Administrative Approval Action

SR-40-18, North Raleigh Radiator & Automotive
Transaction# 553498, AA#3865

REQUEST: Development of a 1.29 acre tract zoned CX-3-PL into a 6,000 square foot single story major vehicle repair structure.

ELEVATIONS **A-3**

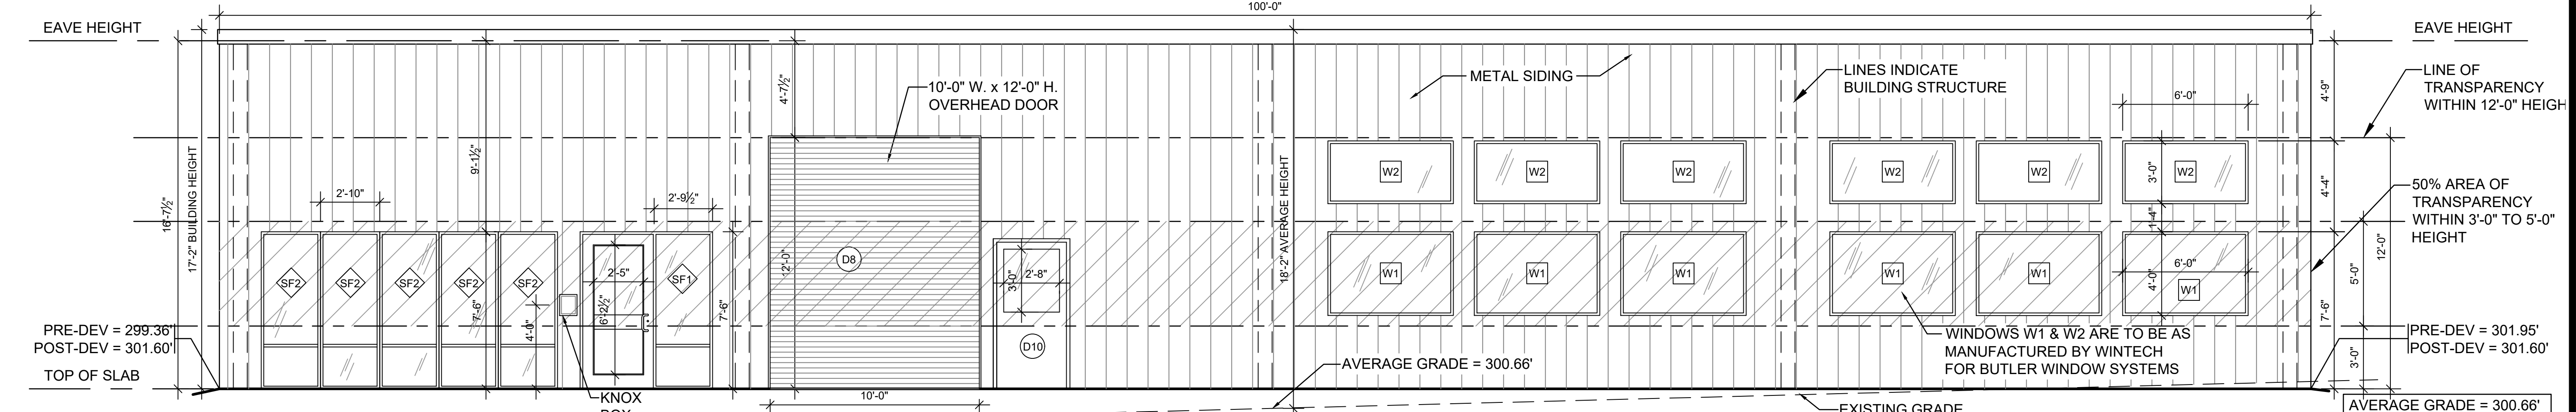
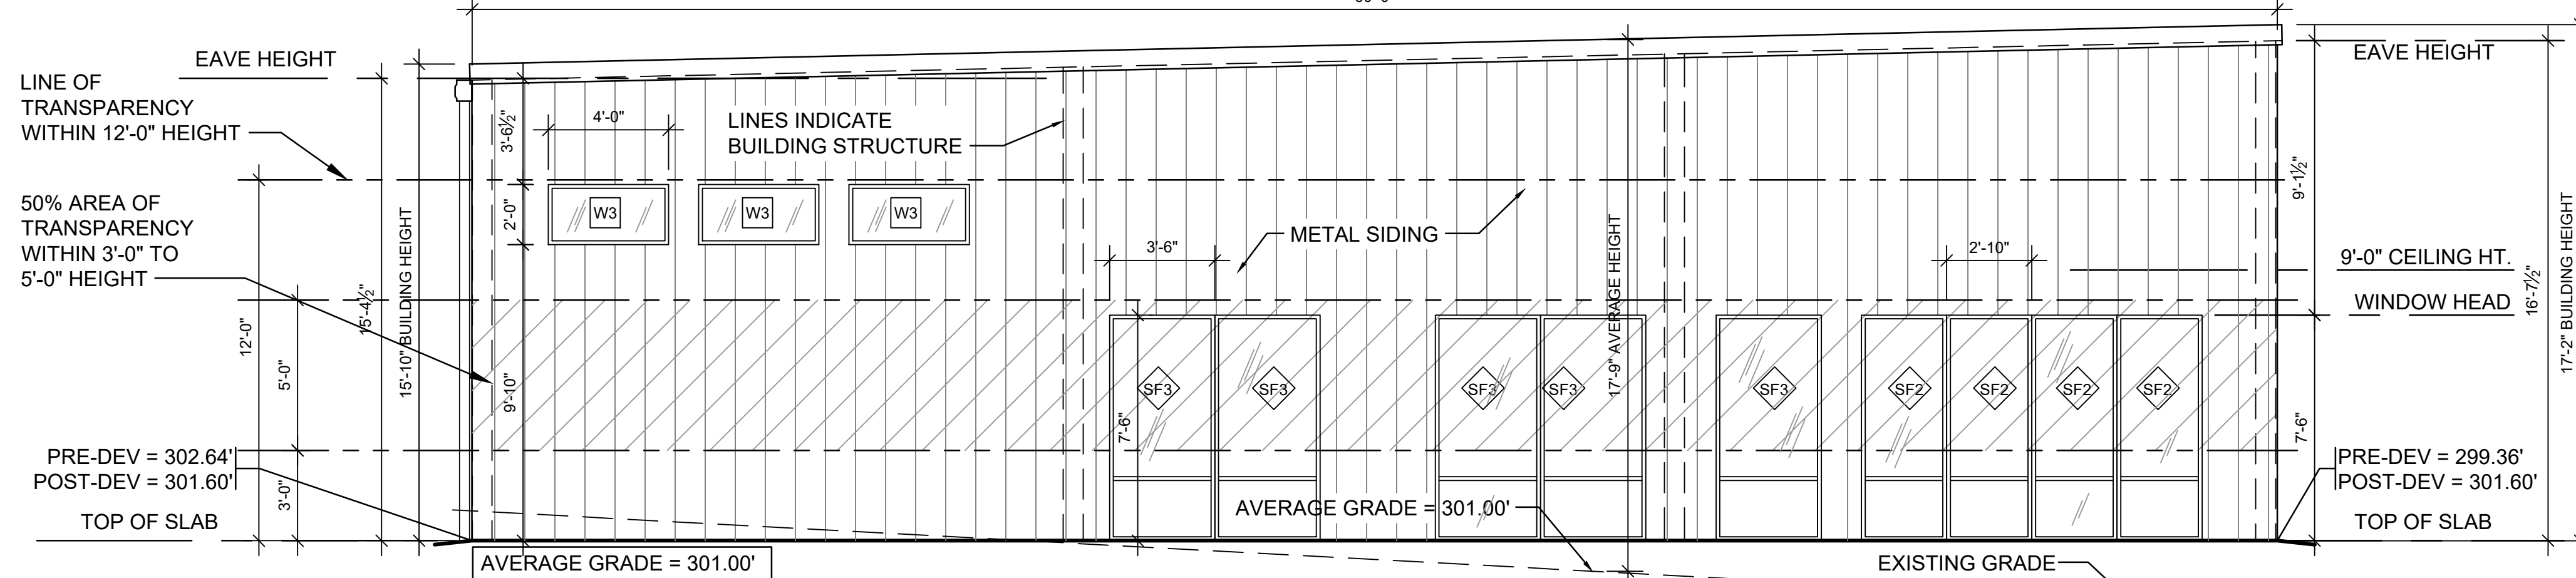
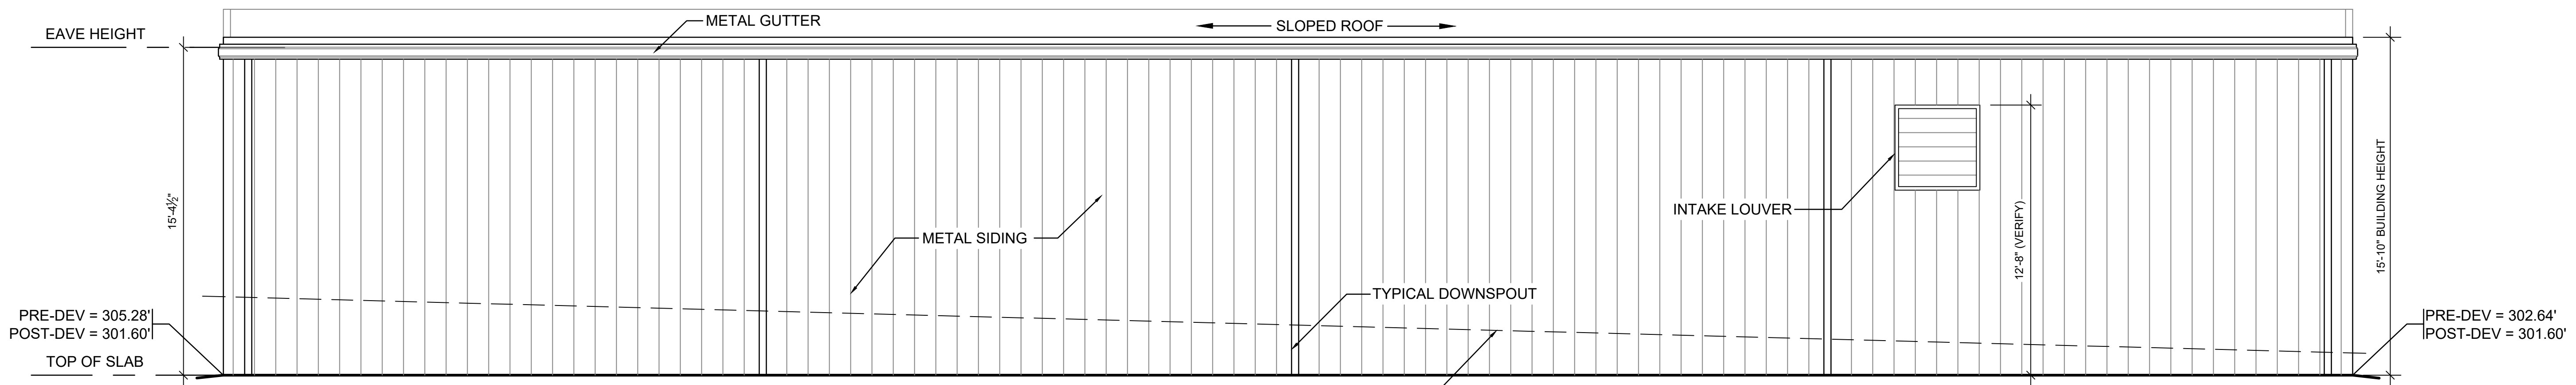
7. On the elevation sheets and illustration renderings, the label: "50% area of transparency within 3'0" to 5'-0" height" shall be revised showing the correct height distance requirements per UDO Sec.1.5.9.B.1, of "3'ft to 8'ft". This note should be revised on final architectural plans at submittal.

8. The transparency calculations table shall be revised, as a result and if necessary, to reflect the revised area/sq.ft between 3'ft to 8'ft per condition number 7 above. NOTE, since the table labels list 3'ft to 8'ft on the transparency table on the proposed preliminary plan but not on the elevation renderings revised calculations might not be required. If the data in the transparency table is correct and reflects the area between 3' to 8'ft, then no revision to the transparency calculations will be required on the final architectural plans for permitting. If not, then the entire table, including calculations, need to be revised to reflect the area between 3'-8'ft per UDO Sec.1.5.9.B.
